REQUEST FOR DECISION

OCP and Zoning Amendment Application
Tyax Real Estate – Tyax Lodge

Meeting date: January 13, 2016

File No. 3360.20.89

Area calculation for MUNICIPAL GROSS FLOOR AREA only

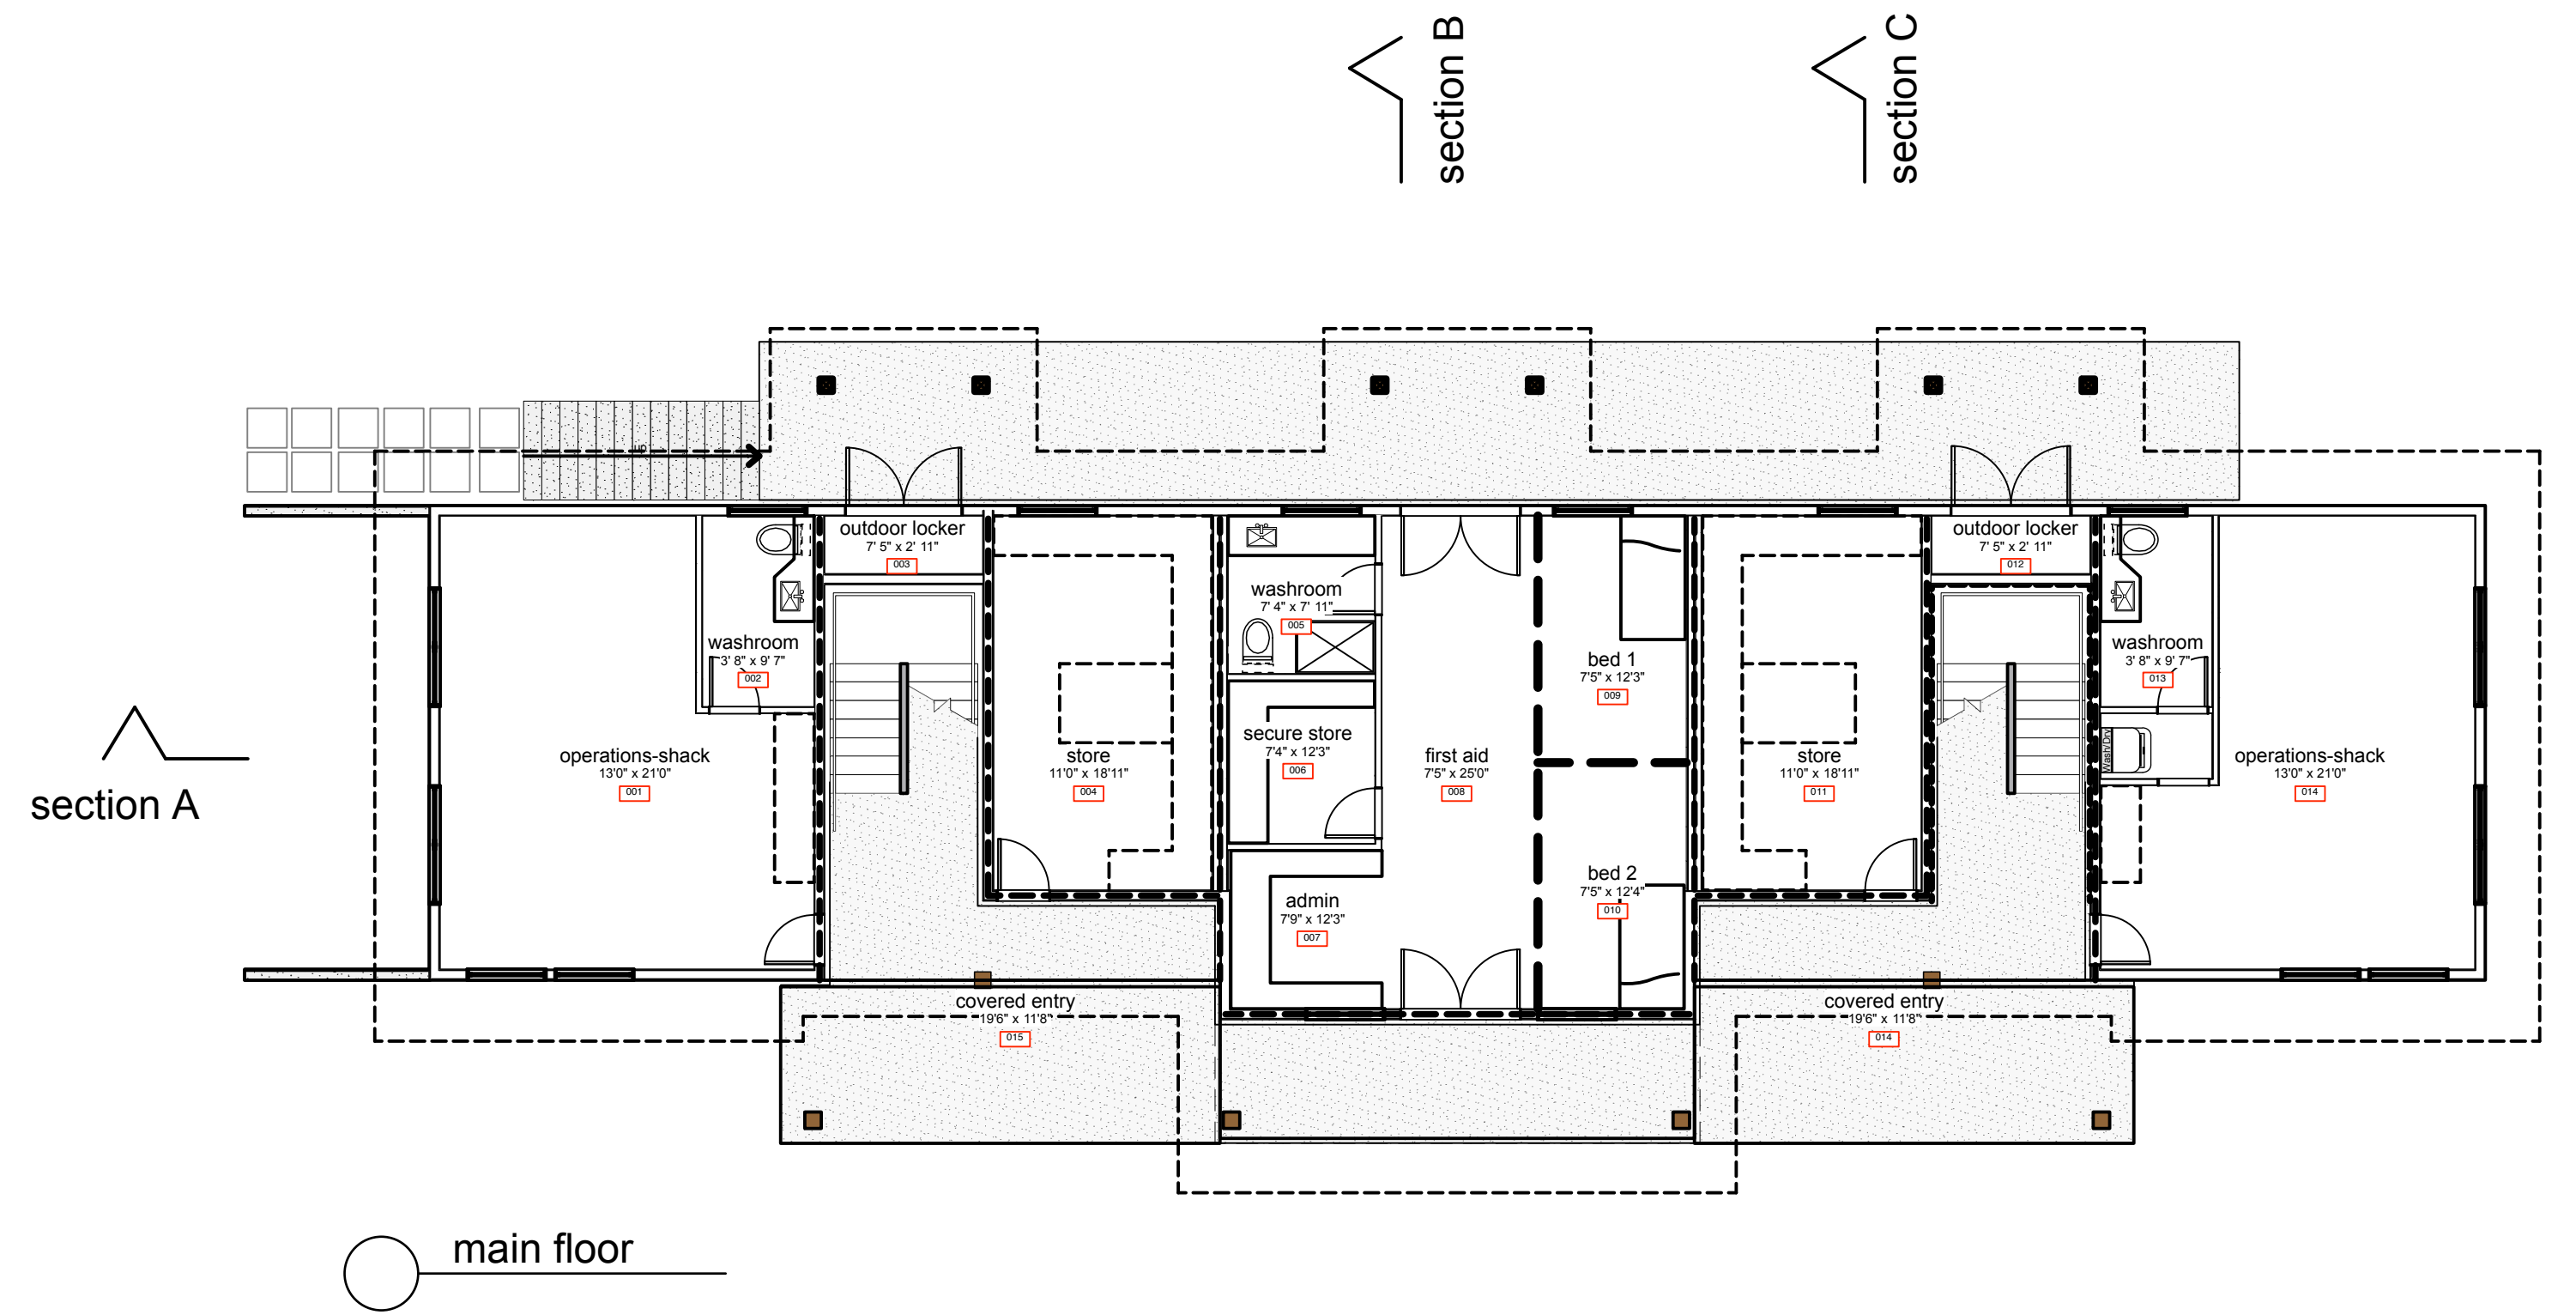
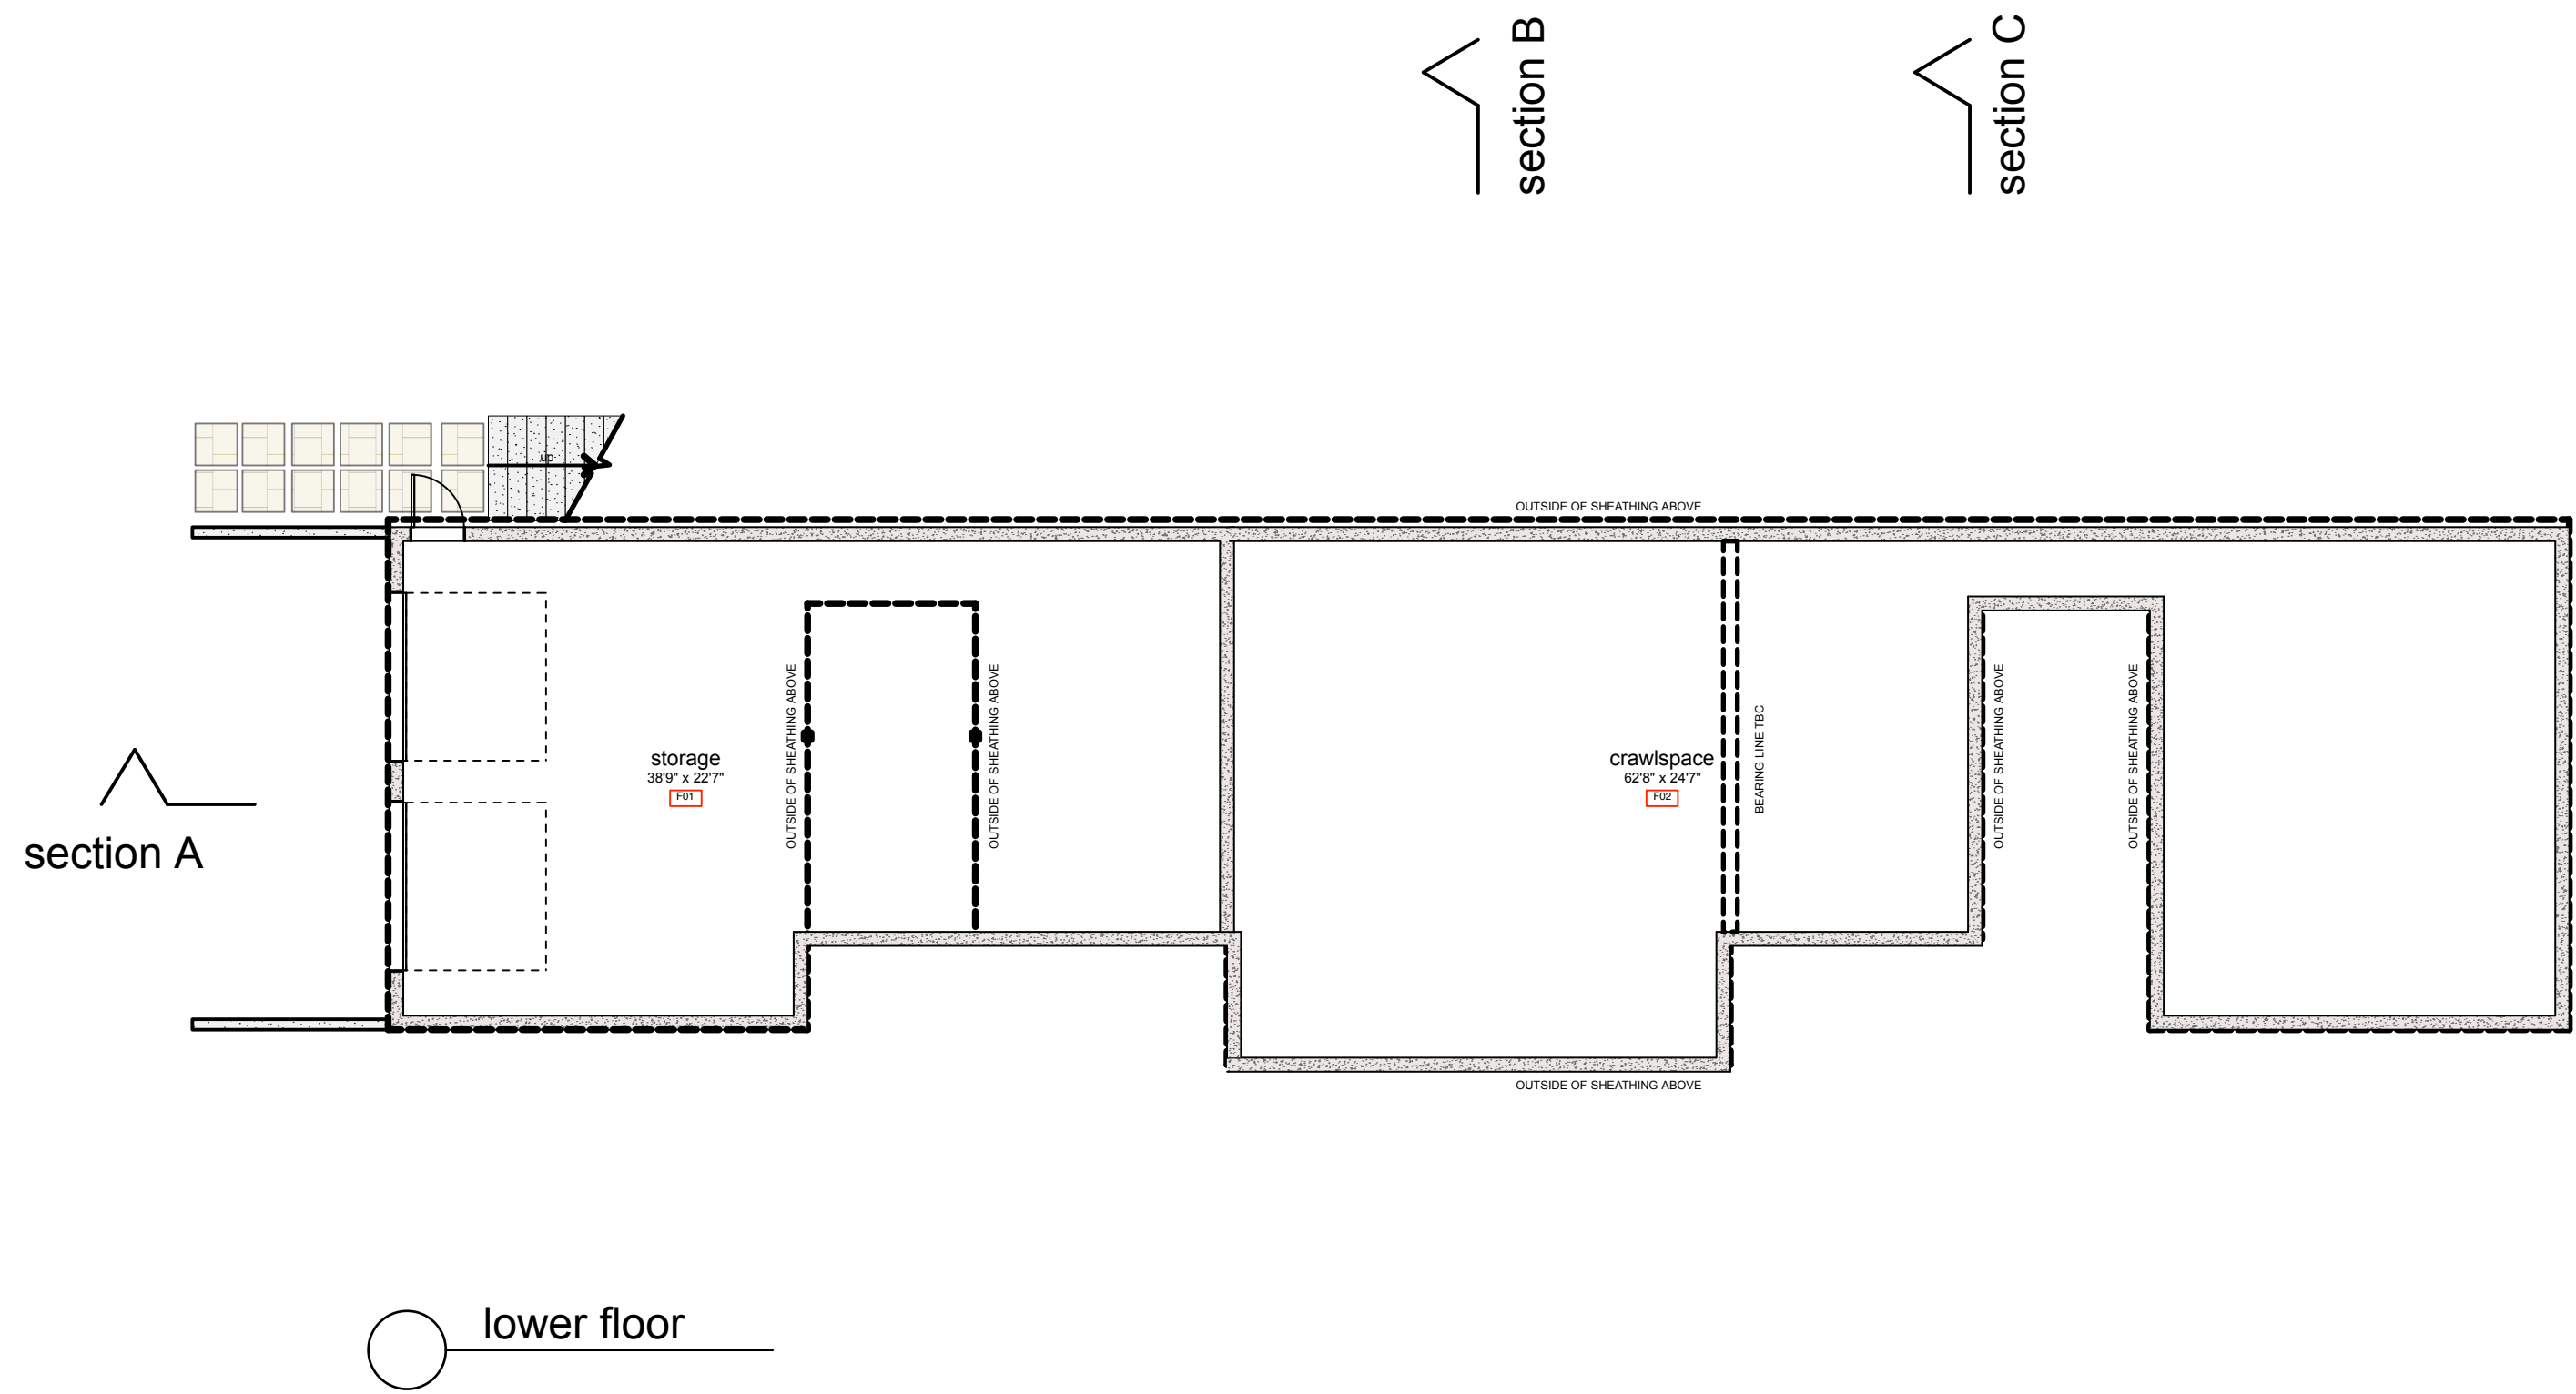
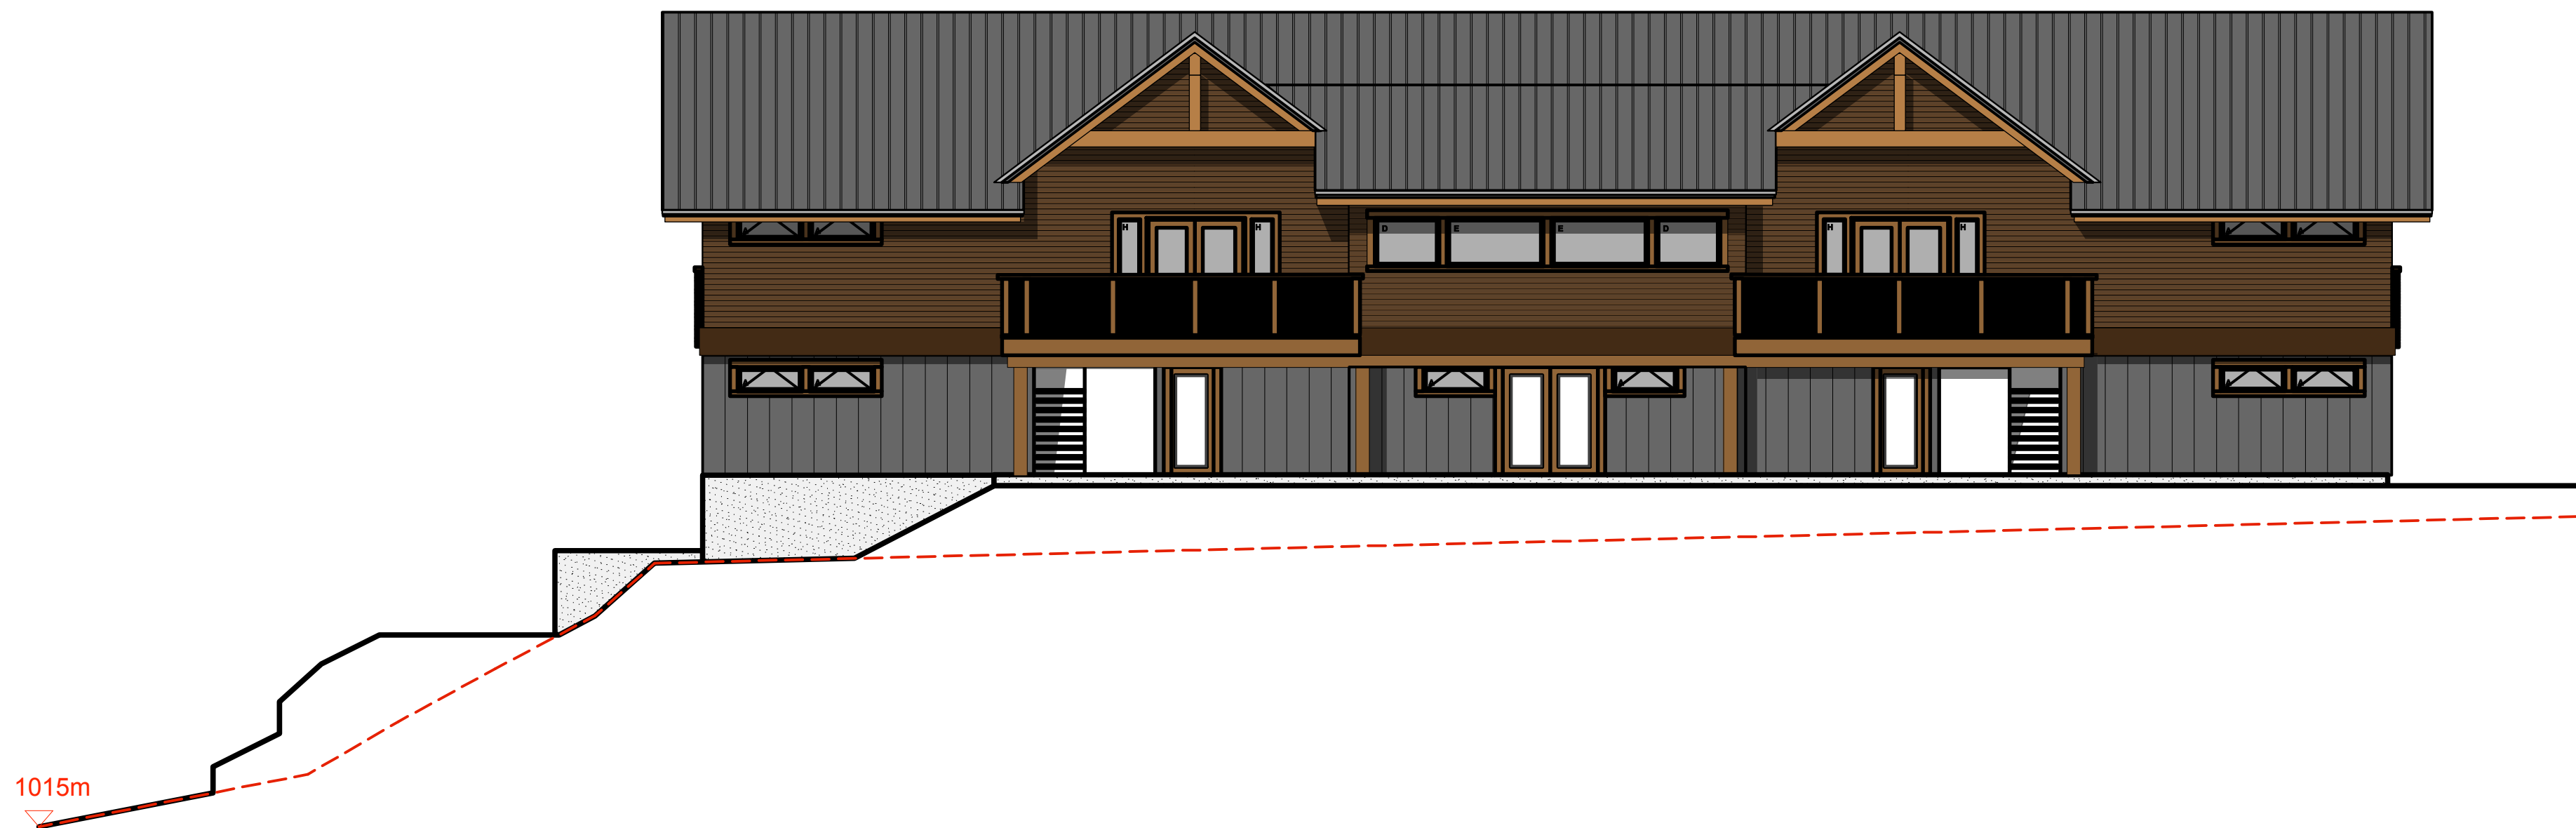
c/ Clarify floor area calculations :

The revised application provides more precise gross floor area of the proposed operations building along with it's main floor footprint.
